Engine Oil Capacity –  
Increased Level –  
New Dipstick

MODEL  
2000 MY-ON XK8 Range  
2000 MY-ON V8 XJ Series  
VIN  
A00367-ON  
F00464-ON

ILLUSTRATION 1

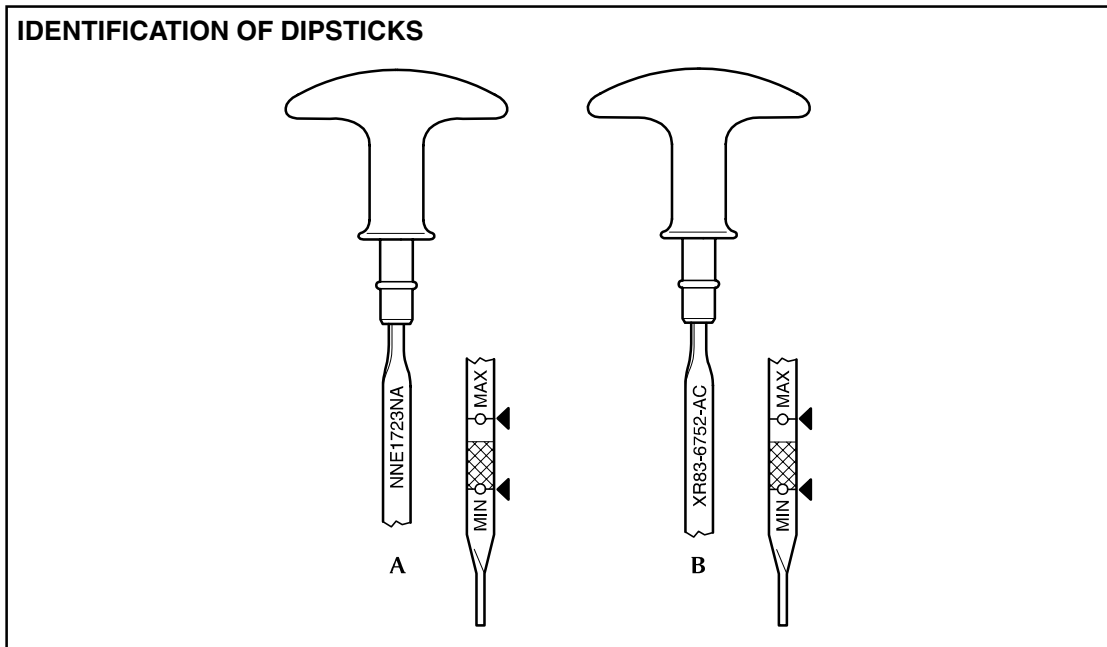
As a running change in production, introduced early in 2000 Model Year XK8 and V8 XJ Series vehicles, the engine oil fill has been increased by 1.0 liter from the VINs listed above. This has been achieved by installing a revised dipstick, part no. XR8 2806.

Pre VINs listed above: Illustration A - NNE 1723NA

From above VINs: Illustration B - XR83-6752-AC

Where appropriate, customers taking delivery of 2000 Model Year XK8 and V8 XJ Series vehicles from the above VINs should be advised of this change. A supplement outlining the change in specification will be included with the owner's handbook.
